RE: Fisheries and Oceans Canada Second Round of Information Request for the DeBeers Canada Gahcho Kué Diamond Mine Project

**DeBeers Canada Gahcho Kue Project
Fisheries and Oceans Canada Topic Specific Round Two Information Requests**

Appendix A - Department of Fisheries and Oceans Comments on Draft Conceptual Flow Mitigation Plan – May 8th, 2012

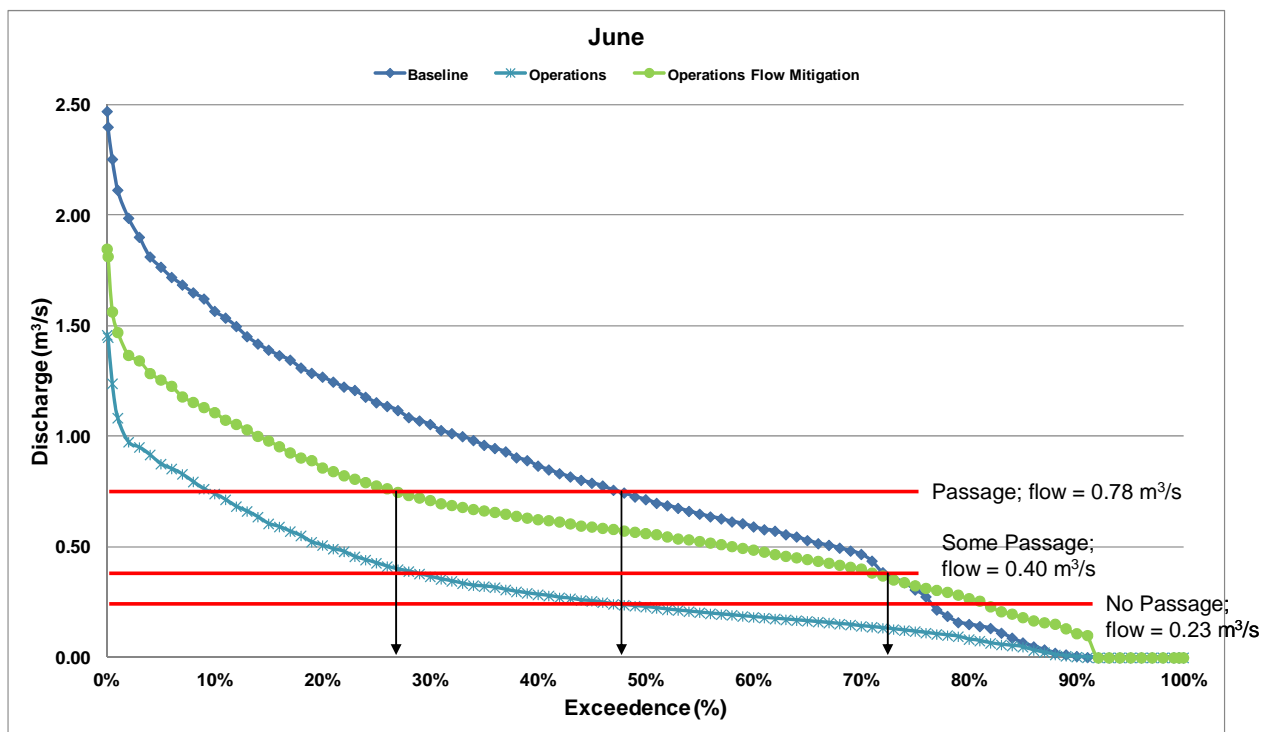
According to the memorandum, natural barriers to fish passage exist at a discharge of $0.23 \text{ m}^3/\text{s}$, and are absent at a discharge of $0.78 \text{ m}^3/\text{s}$, and the transition discharge where fish passage is not affected is unknown. The three month timing window for grayling to access, utilize and return from their spawning and rearing habitat is relatively short and any delay in access to the habitat due flow limitations may affect spawning or rearing success. It is therefore very important to ensure that the discharge at the start of migration season is designed to minimizing delay and provide a high degree of passage success.

A comparison of the flow frequencies for the barrier to passage discharge values presented in the memorandum was made using the June Flow Exceedance Curve (Figure 1). The summary table shown below presents the results of the comparison.

For the 0.40 m³/s discharge value that was used to develop flow targets for the mitigation plan and was assumed to provide “some passage” the flow exceedence is approximately 73% which equals the baseline value and would reflect the 3 out of 4 year passage criteria objective.

However, as stated in the memorandum, more information on the passage effectiveness at the 0.40 m³/s discharge is required before this value can be accepted.

For the 0.78 m³/s discharge value that was identified as a “no barrier” to passage, the flow exceedence drops to 47 percent for baseline and only 27 percent for the proposed mitigation flow. The difference in flow frequency in this comparison illustrates the importance of establishing the correct migration discharge criteria.

Underestimating the flow releases for the June migration period could limit the use of the spawning and rearing habitat by increasing the frequency when grayling are unable to access the habitat as well as increasing the delay to gain access to the habitat.

- Focus flow augmentation requirements on the June migration period in order to maximize access to the spawning and rearing habitat. If grayling cannot access the habitat, they cannot use it.
- Develop a better understanding of the relationship between migration flow required to access the habitat and the flow that is needed to sustain the habitat during the spawning and rearing period (wetted habitat). Flow criteria should be designed to avoid the case where habitat is not utilized due to accessibility limitations.
- Has water velocity as a potential barrier to passage at higher flows been consider in the flow mitigation plan?
- If capacity of the water source that will provide supplementary flow is not limited, would it be possible increase mitigation flows to more closely match baseline flows and improve utilization of the spawning and rearing habitat?
